SEGA OF AMERICA, INC.  
Consumer Products Division

# **32X Technical Information**

Doc. # MAR-41-R8-090694

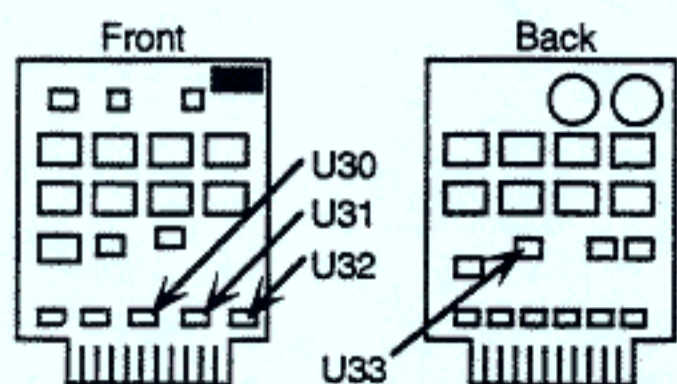
- The following modifications are necessary when a Mega Drive 32 Mbit SRAM board is used with the 32X.

#### Work Procedure

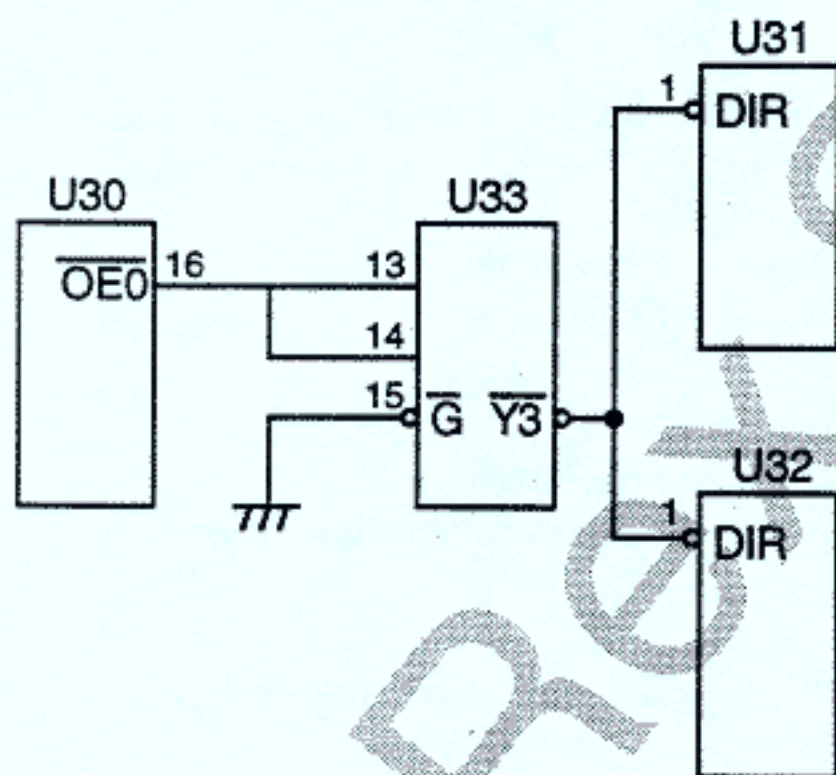
- The following modifications are necessary when a Mega Drive 16 Mbit SRAM board is used with the 32X.

- Lift no. 1 pins of U31 and U32.
- Similarly, lift no. 13, 14, and 15 pins of U33.
- Jump the no. 16 pin of U30 and the no. 13 and 14 pins of U33.
- Connect the no. 15 pin of U33 to the GND (no. 8 pin).
- Jump the no. 9 pin of U33 to each no. 1 pin of U31 and U32.

#### After Modification

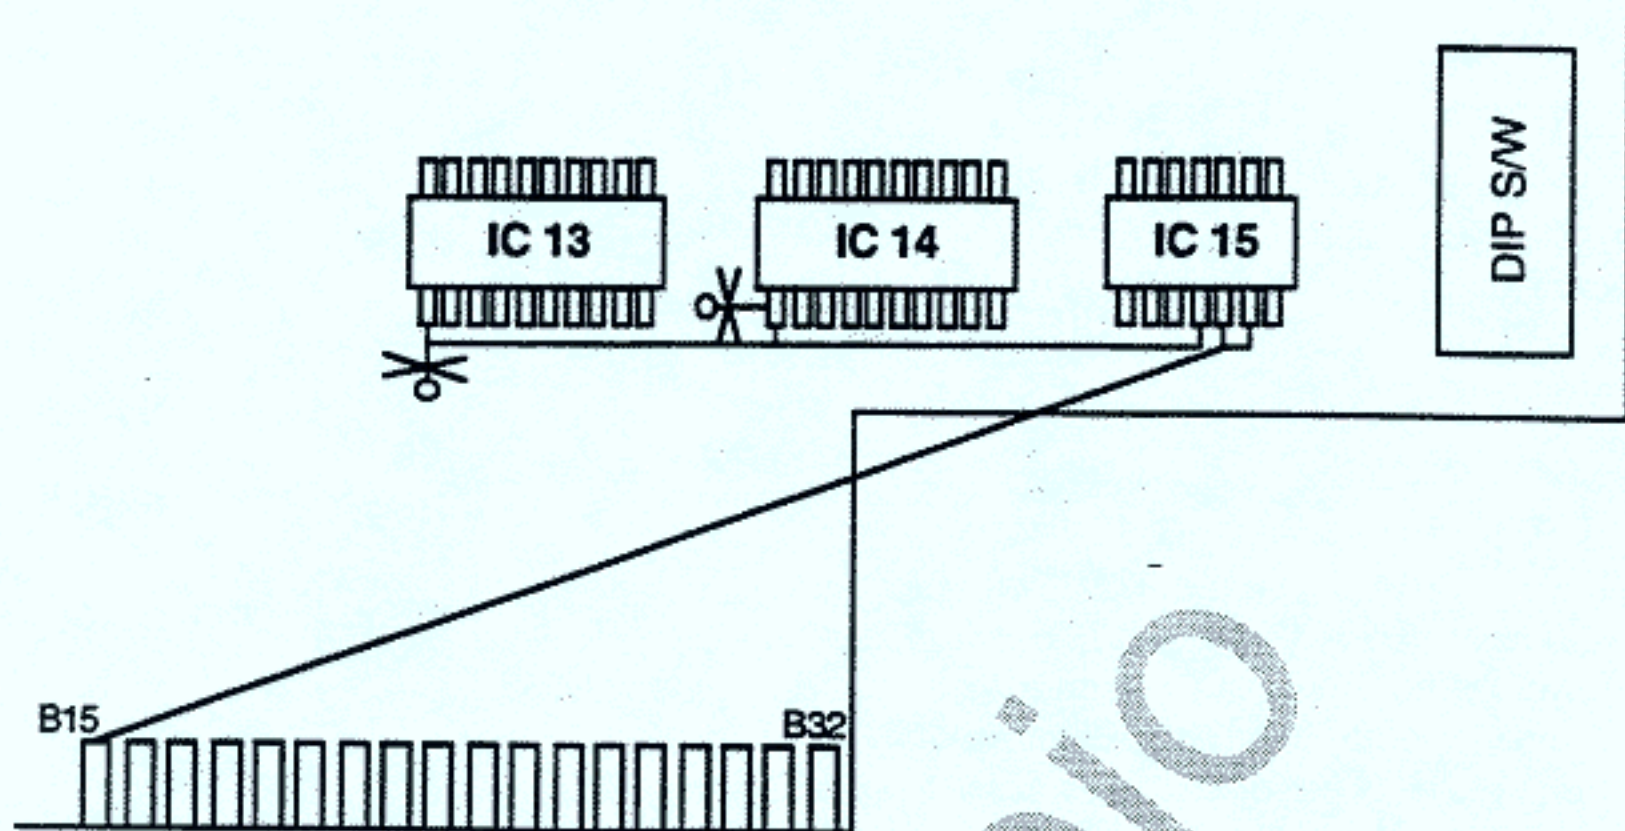
Operation cannot be guaranteed if U31 and U32 are not AC or ALS type. If equipped with the LS type, the AC or ALS type should be attached, replacing the LS type.
